Title: Extension Board

Size: C | Document Number: HDMI TX | Rev: SA

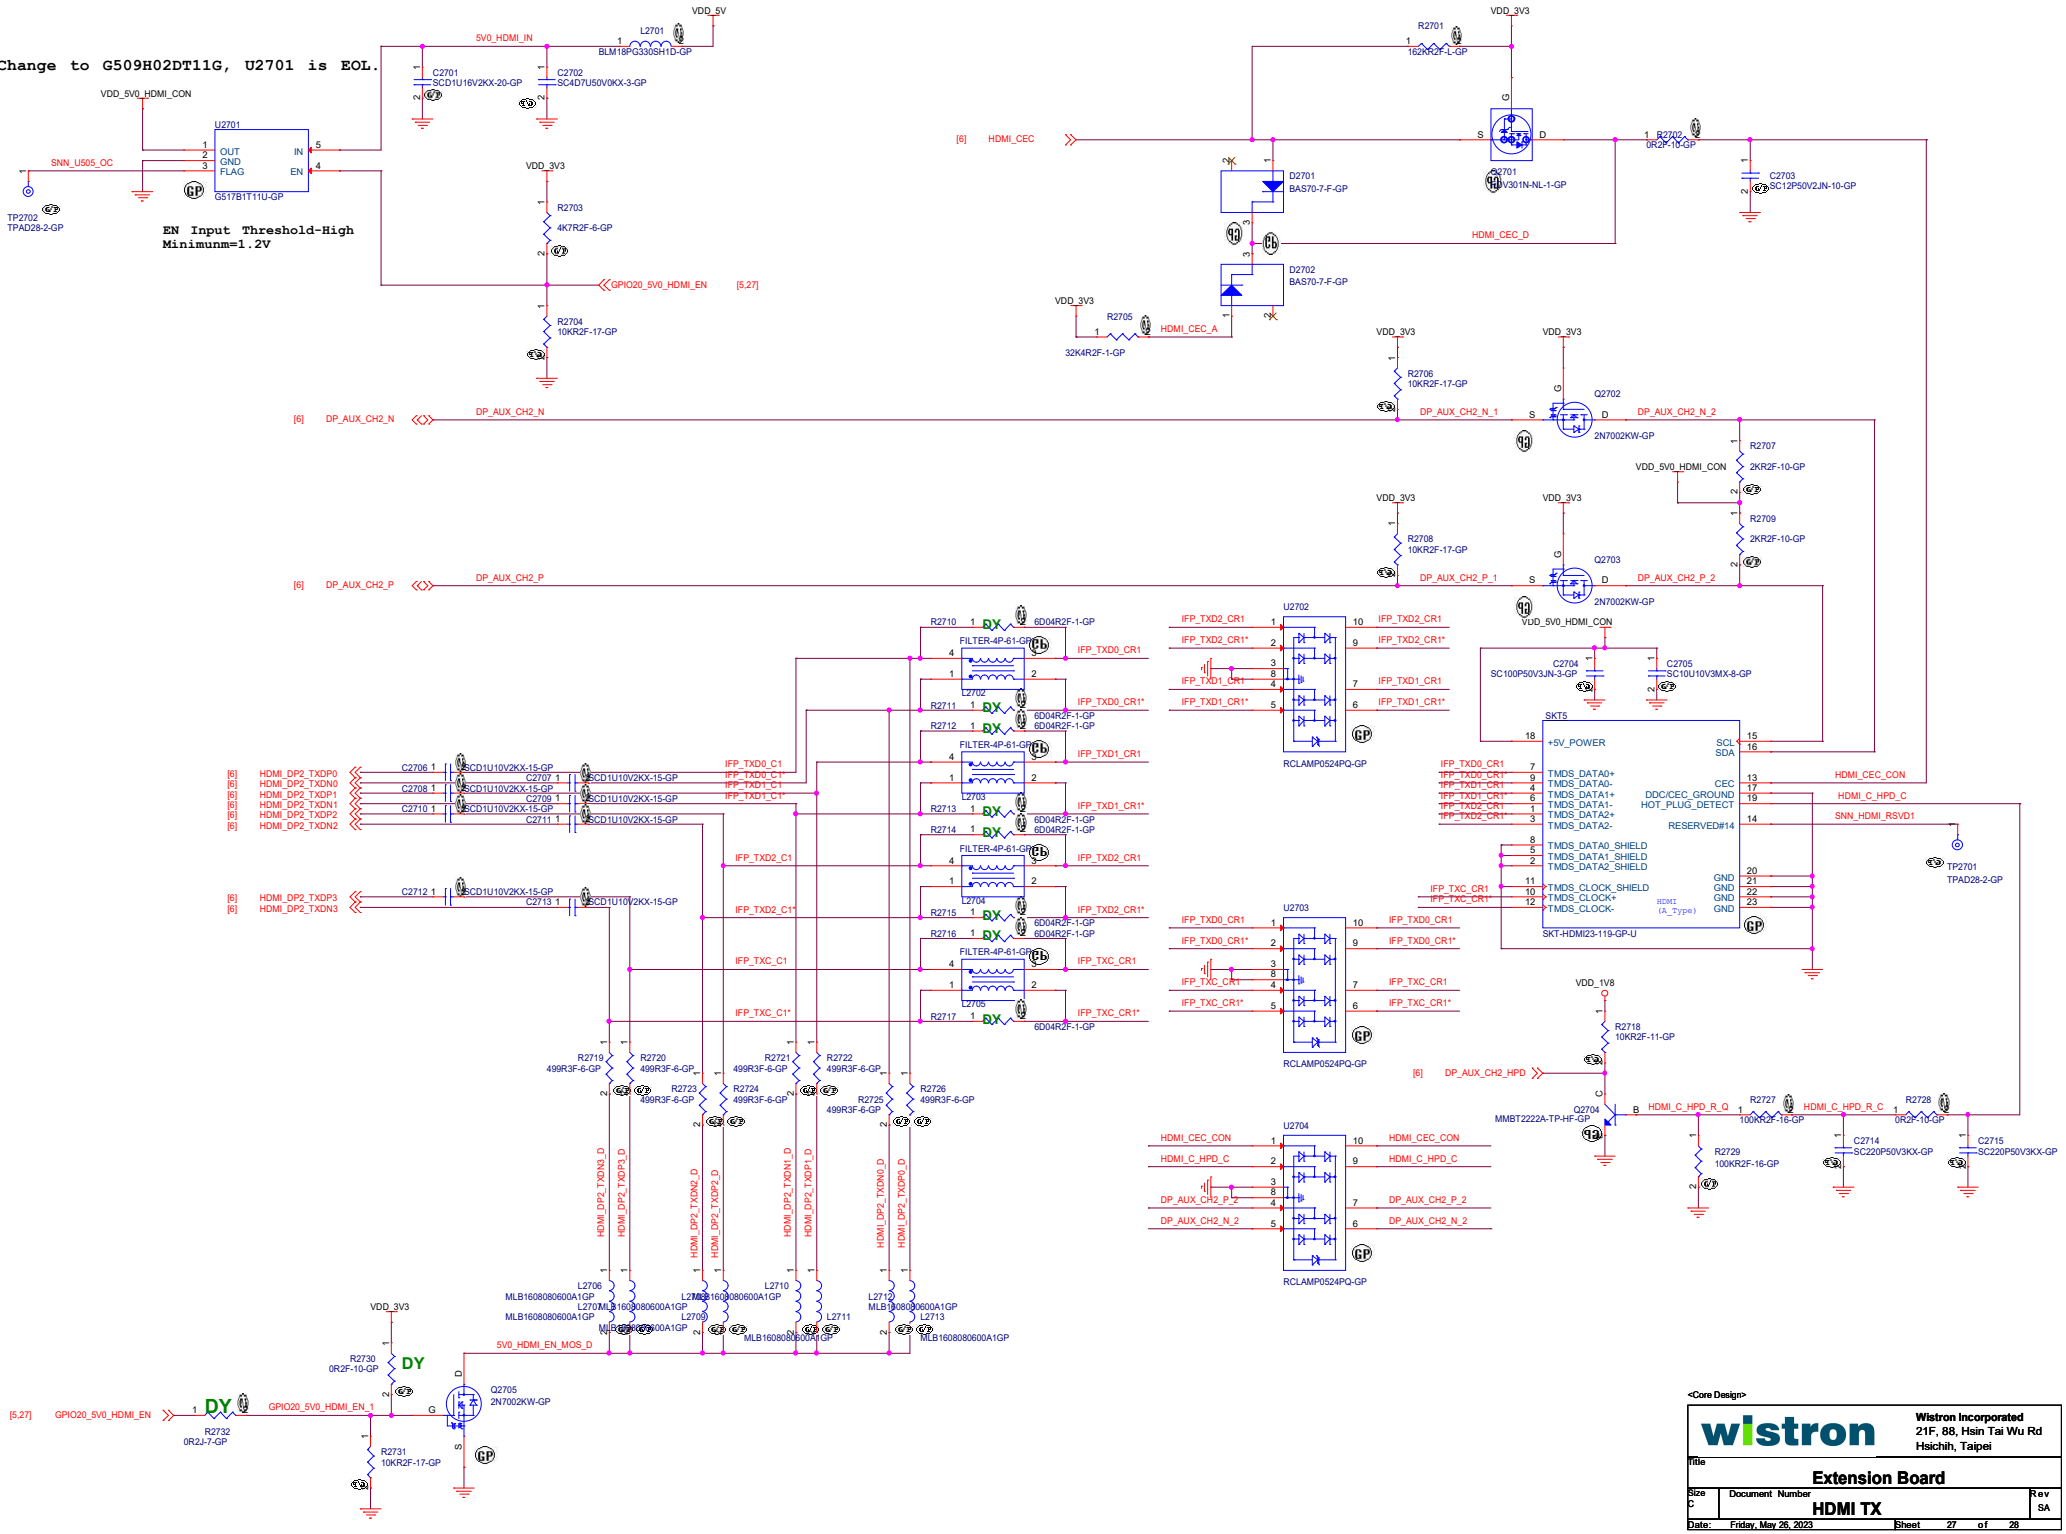
Change to G509H02DT11G, U2701 is EOL.

EN Input Threshold-High Minimunm=1.2V
